FORD CAST IRON FMX

2-3 FLARED SHIFT

Figure 1

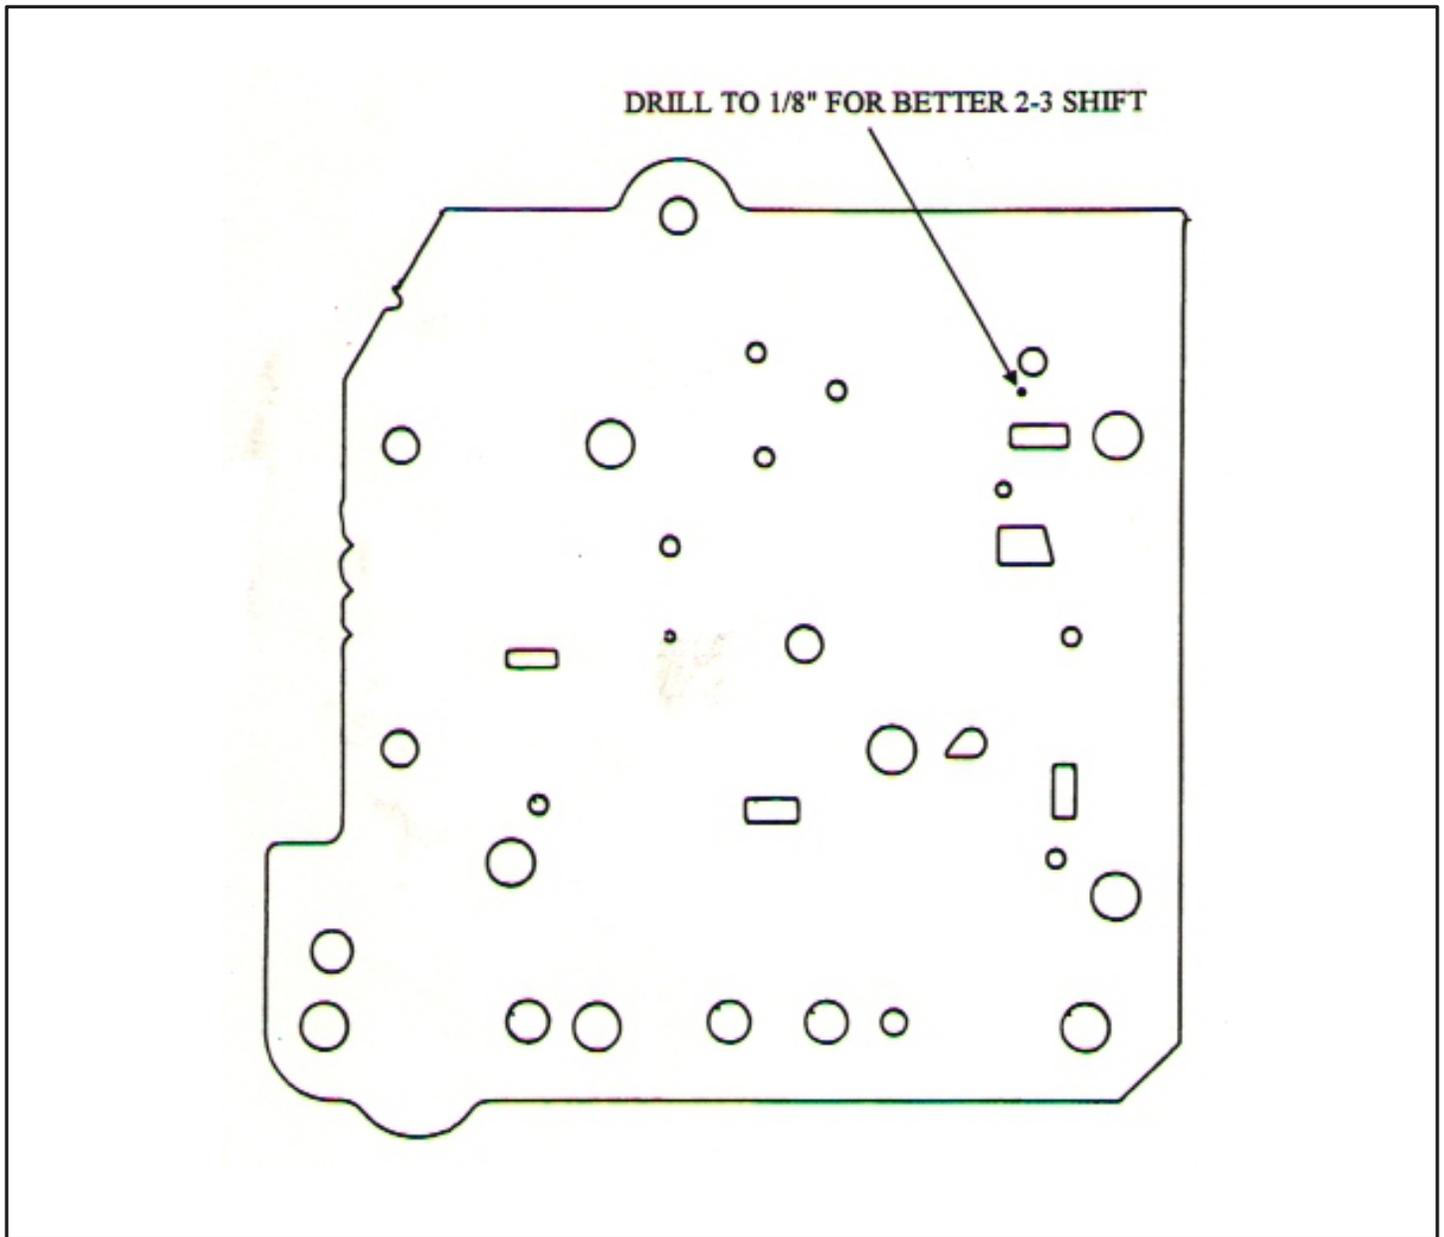
After overhaul an FMX transmission may have a 2-3 flared shift. The main valve body spacer plate has a small hole over the 2-3 orifice check ball as seen in figure 1. Drill this hole out to 1/8".
